Access Compliance Report

Public Rights-of-Way

(Curb Ramps)

Intersection ID: 24333	Main Street: BIRNEN_DR	Cross Street: GLISSON_CT	Location: NE
ADA ID: 88F3FACA3B9B	Ramp Type: BlendTrans1	Initial Pass/Fail: Pass	Overall Compliance: No
		Severity Score: 10

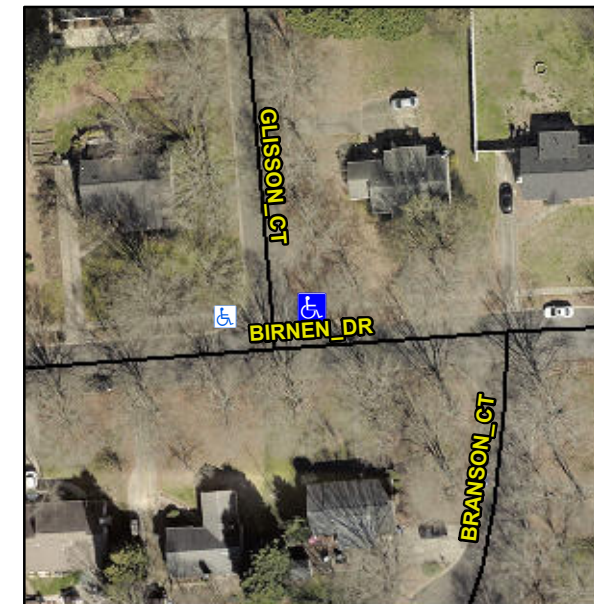
Not Found, R304.5.3, R305

Remove & Replace Curb Ramp With Two New Directional Ramps or Equivalent.
